METROPOLITAN GOVERNMENT OF NASHVILLE AND DAVIDSON COUNTY

STAFF RECOMMENDATION
2517 Blair Boulevard
January 16, 2019

Application: New Construction—Outbuilding, addition
District: Hillsboro-West End Neighborhood Conservation Zoning Overlay
Council District: 18
Map and Parcel Number: 10415002700
Applicant: Blaine Bonadies
Project Lead: Melissa Baldock, melissa.baldock@nashville.gov

Figure 2. The existing outbuilding

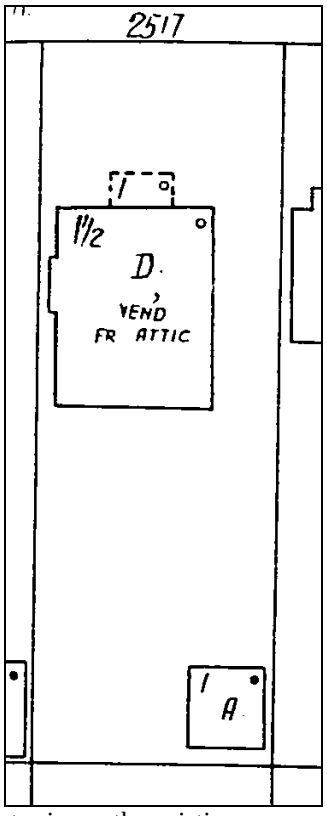
Background: 2517 Blair Boulevard is a c. 1932 brick bungalow. The date of construction of the existing outbuilding is not known, but it is likely the same structure that appears in the c. 1932 Sanborn Map (Figures 2-4).

Figure 5. The proposed roof form combines a cross gable and large dormers.

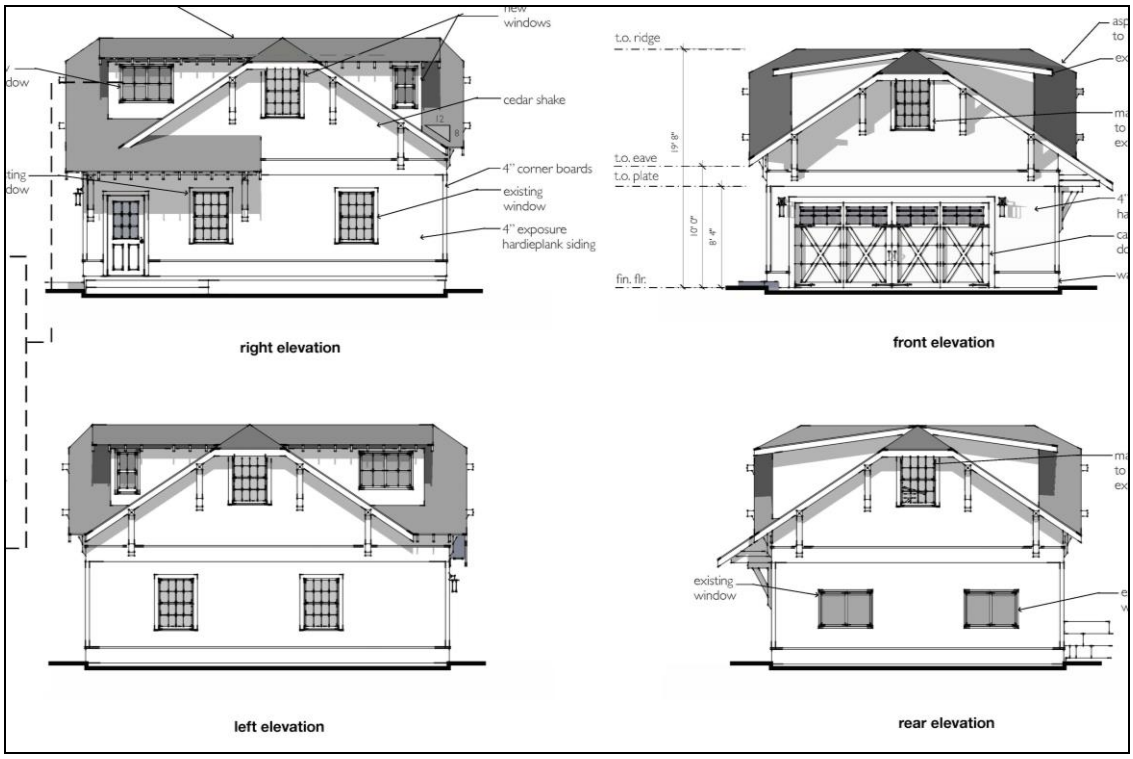
*The design of the roof combines both dormers and a cross gable form in a manner that has not been approved by the Commission in the past (Figure 5). The design guidelines state that dormers should cover no more than fifty percent (50%) of the roof and should be set back two feet (2') from the wall below. As the roof plan shows, combining the cross gable form with the dormers on either side results in very large dormers that cover almost all of the roof plane (Figure 6). In addition, one dormer on the right elevation, towards the back, is not set back two feet (2') from the wall below, as is required. In the

past, the Commission has generally not approved dormers that attached to a secondary roof plane as historically dormers were typically stand-alone roof features.

Staff finds that the dormers combined with the cross gable form do contrast greatly with the historic house and neighborhood, as it not a typical roof form for the neighborhood for either historic houses or outbuildings. In addition, the combination of dormer and cross gable pushes the scale of roof and the outbuilding to be incompatible with the historic house's roof form and the design guidelines. Staff therefore finds that the proposed roof form does not meet Section II.B.h. of the design guidelines. Staff recommends that a condition of approval be that the dormers be removed from the cross gable form, or that a simple side gable with dormers that cover no more than fifty-percent (50%) of the roof and that are set back two feet (2') from the wall below be used.

1. The dormers be removed from the cross gable form, or a simple side gable roof form be used with dormers that cover no more than fifty-percent (50%) of the roof and that are set back two feet (2') from the wall below;
2. Staff approve all windows and doors prior to purchase and installation.

site plan
scale: 1" = 20'

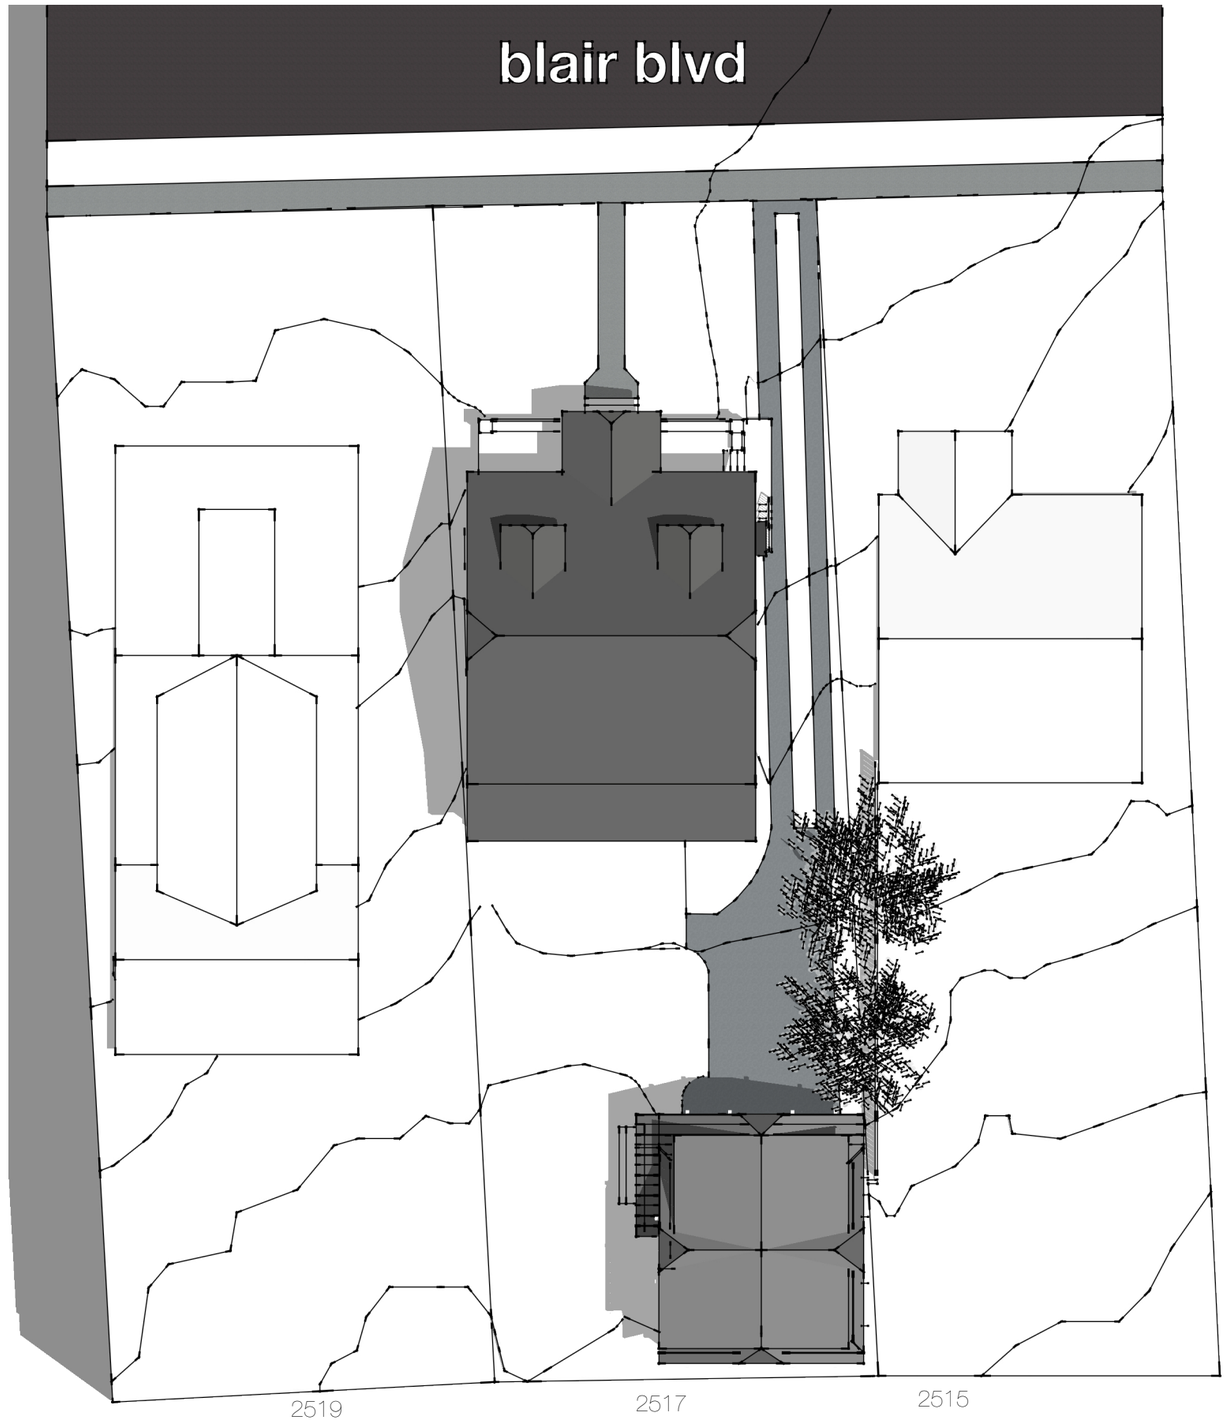
* Base zoning requires a five foot (5') side setback when the outbuilding's footprint is larger than seven hundred and square feet (700 sq. ft.) like this one. The existing outbuilding is seven hundred and forty-eight square feet (748 sq. ft.). It does not meet base zoning setback on the left side. The existing structure is just one foot (1') from the left side property line towards the front and is approximately two feet, eight inches (2'8") from the side property line at its rear. Staff finds that increasing the height of the outbuilding from one-story to one-and-a-half-stories and from approximately sixteen feet (16') tall to nineteen feet, eight inches (19'8") could be appropriate if the rest of the outbuilding meets the design guidelines. At the June 2018 MHZC public hearing, several MHZC Commissioners expressed support of the reduced setback since the garage is existing and the footprint of the garage is not changing. .
